World Forum for Harmonization of Vehicle Regulations

Proposal for 02 series of amendments to Regulation No. 127 (Pedestrian safety)

Submitted by the Working Party on Passive Safety *

Figure 5A
Corner of bumper example (see paragraph 2.17., note that the corner gauge is to be moved in vertical and horizontal directions to enable contact with the outer contour/ front fascia of the vehicle)

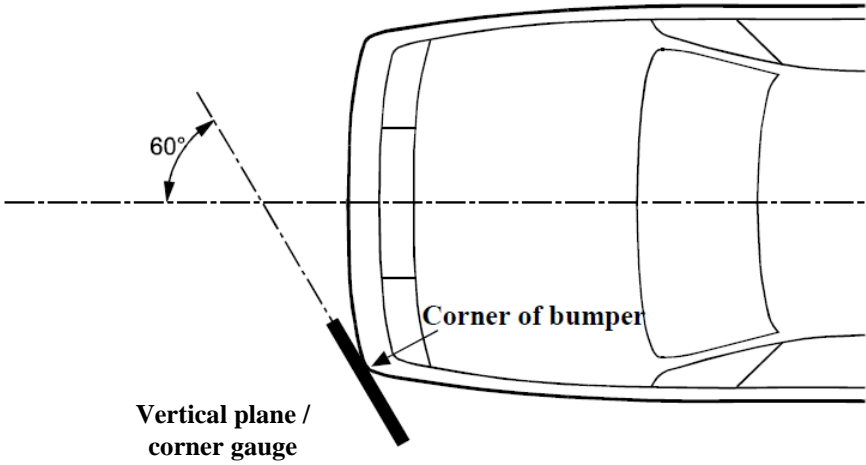
Former paragraph 2.16.(including Figure 5), renumber as paragraph 2.17. and amend to read:

"2.17. "Corner of bumper" means the transversal position of the vehicle's point of contact with a corner gauge as defined in Figure 5B.

For determination of the corner of bumper, the front surface of the corner gauge is moved parallel to a vertical plane with an angle of 60° to the vertical longitudinal centre plane of the vehicle (see Figures 5A and 5C) at any height of the centre point of the corner gauge between:

For determination of the corner of bumper, the gauge is moved to contact the outer contour/front fascia of the vehicle touching at the vertical centre line of the gauge. The horizontal centre line of the gauge is kept parallel to the ground plane.

The corners of bumper on both sides are subsequently defined as the outermost points of contact of the gauge with the outer contour/front fascia of the vehicle as determined in accordance with this procedure. Any points of contact on the top and the bottom edges of the gauge are not taken into account. The external devices for indirect vision and the tyres shall not be considered."

Figure 5B
Corner gauge

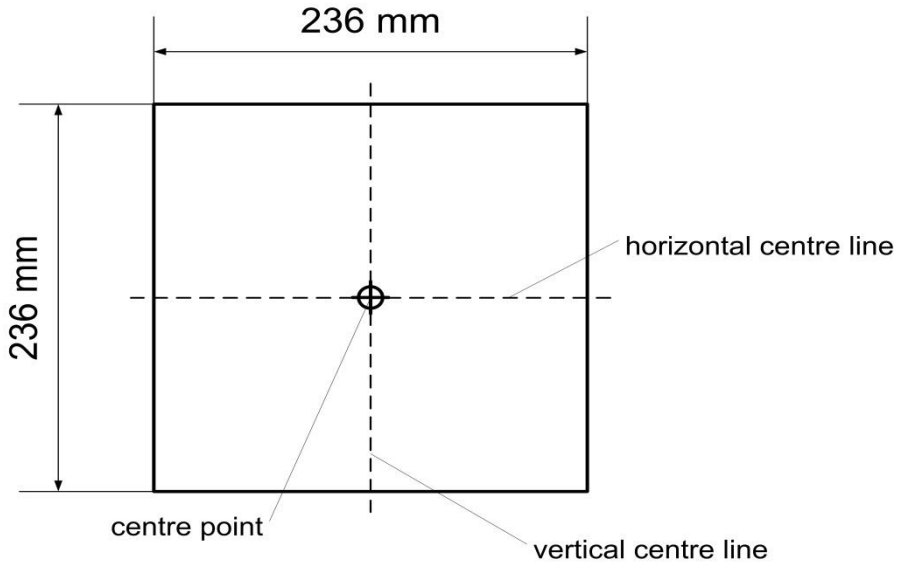
The front surface of the corner gauge is flat.
The centre point is the intersection of the vertical and horizontal centre lines on the front surface.

Figure 5D
Determination of bumper test area (note that the corner gauges are to be moved in vertical and horizontal directions to enable contact with the outer contour/front fascia of the vehicle)

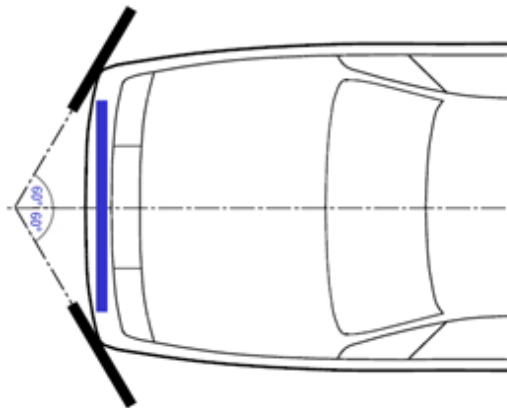
Former paragraph 2.13., renumber as paragraph 2.14. and amend to read:

"2.14. "Bumper test area" means either the front vehicle fascia between the left and right corner of bumper as defined in paragraph 2.17., minus the areas covered by the distance of 42 mm inboard of each corner of bumper as measured horizontally and perpendicular to the longitudinal median plane of the vehicle, or between the outermost ends of the bumper beam as defined in paragraph 2.12. (see Figure 5D), minus the areas covered by the distance of 42 mm inboard of each end of the bumper beam, as measured horizontally and perpendicular to the longitudinal median plane of the vehicle, whichever area is wider."
